West Winder Bypass
CSSTP-0006-00(327), P.I. No. 0006327
Barrow County

Value Engineering Study Report

April 2010

ALTERNATIVE NO.: 33

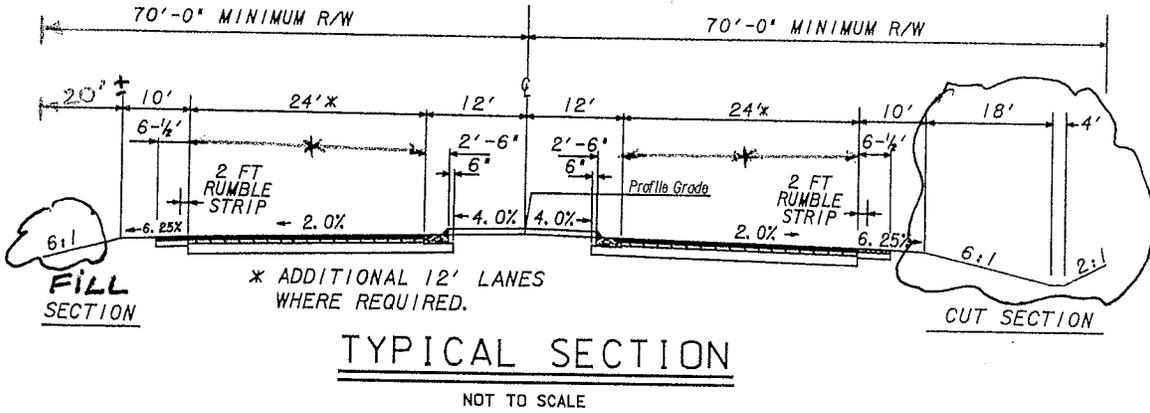
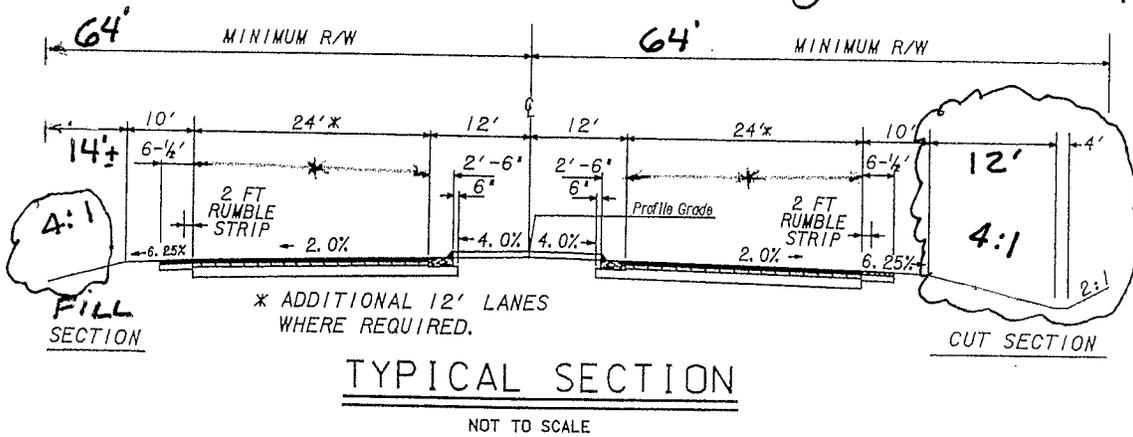
The design speed for Patrick Mill Road is 45 mph, therefore 4:1 slopes meet the design requirements for clear zone and recovery area for vehicles leaving the roadway. This typical section provides 26 ft. (10 ft. + 12 ft. + 4 ft.) of clear zone, which is in the desirable range for 45 mph design speed and 4:1 slopes. This alternate typical section would save 12 ft. of right-of-way where 6:1 slopes are used in cut sections and shallow fills. The length of right-of-way saved in this cost comparison is estimated since there are no earthwork cross-sections available at this time.

(will save 12' of R/W ±)

ALT. NO.
34
Sht. 2 of 2

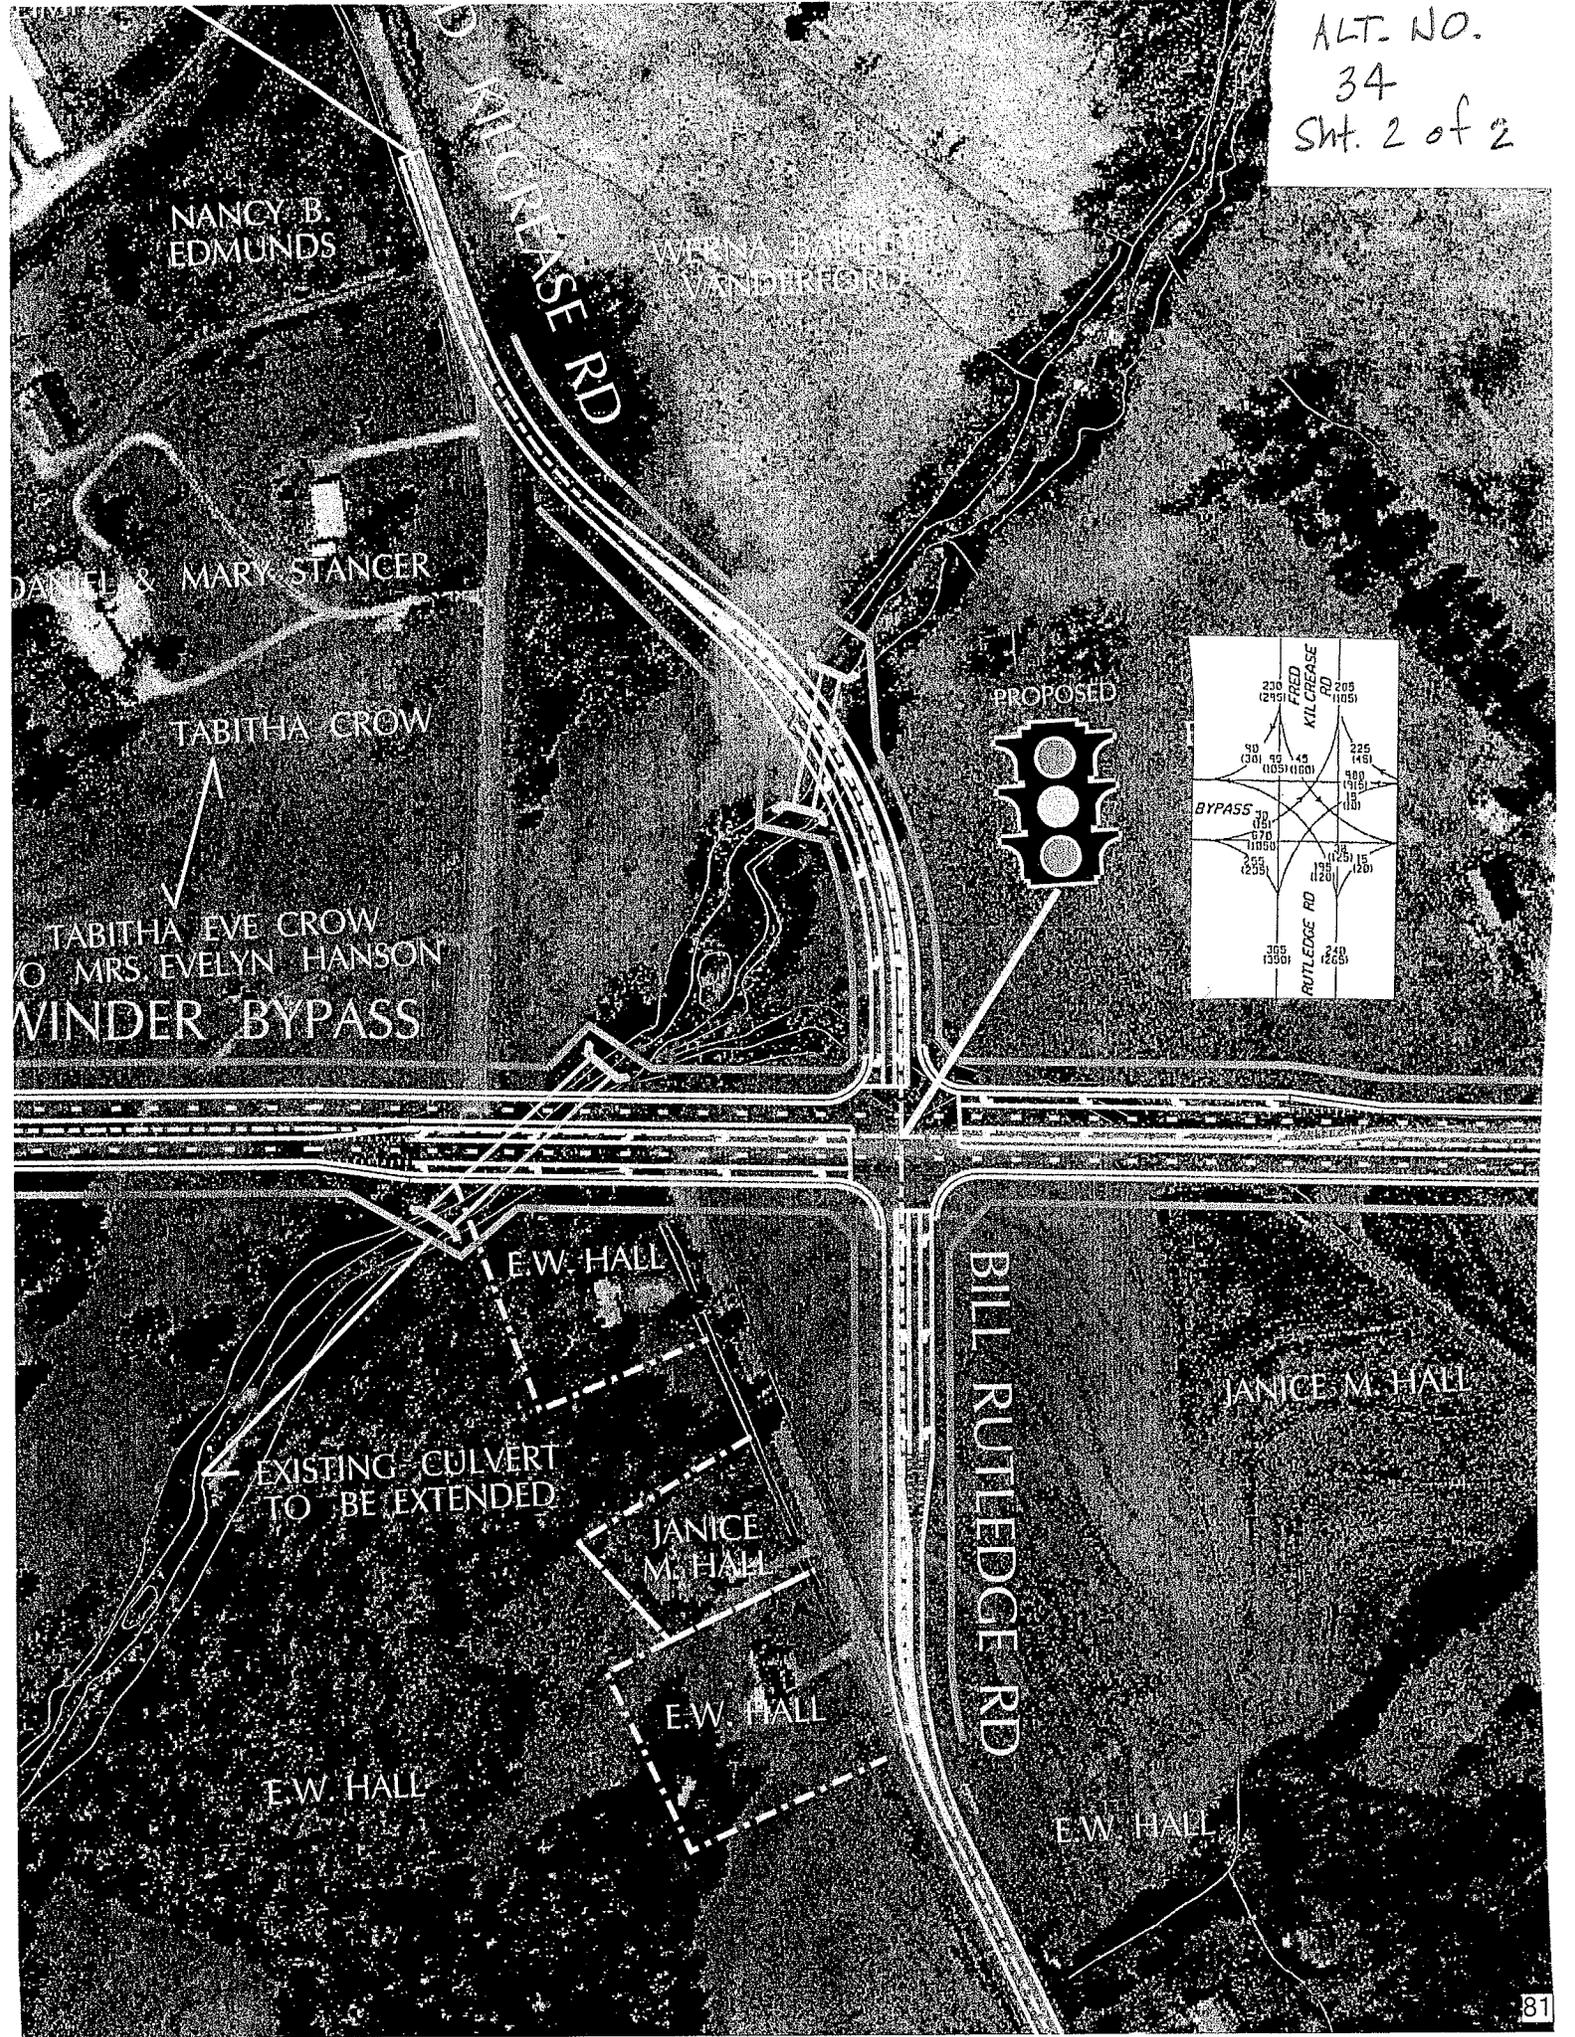
Remove the traffic signal at the intersection of Bill Rutledge Road and Fred Kilcrease Road.

The average cost of a traffic signal derived from the cost data is \$127,000.
